Notice of Intent

Sundry ID: 2706747

Type of Action: APD Change

Top Spot KPLA Bulk Sundry

Figure C] 4 – String – Un Cemented Annulus

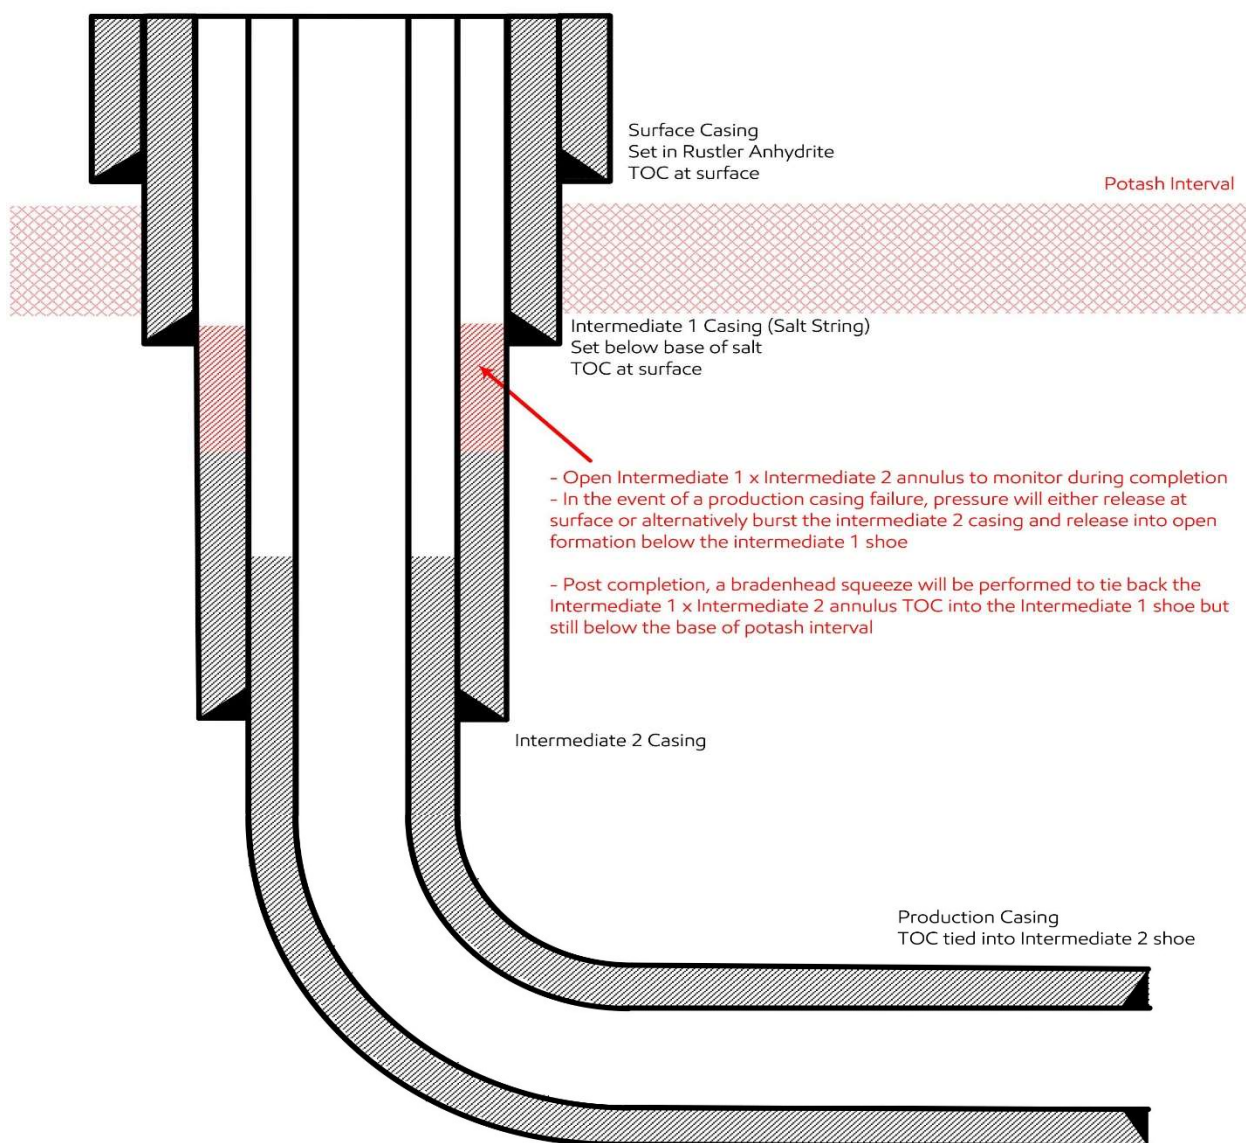
Oxy requests to update the Deep Intermediate Cement Job to align with the agreed upon R111-P updates presented from the JITC. I've included 4 tables below due to the different target benches:

4-String Design – Open Int 1 x Int 2 Annulus

**ALL PREVIOUS COAs STILL APPLY. CEMENT DESIGN UPDATE AS PER
KPLA BEST PRACTICES (4-STRING INT1 X INT2 OPEN ANNULUS)**

Operator has proposed to pump down 7-5/8" X 9-5/8" annulus POST-FRAC. Operator must top out cement after the bradenhead squeeze and verify cement to surface. Operator can also check TOC with Echo-meter. CBL must be run from TD of the 7-5/8" casing to surface if confidence is lacking on the quality of the bradenhead squeeze cement job. Submit results to BLM.
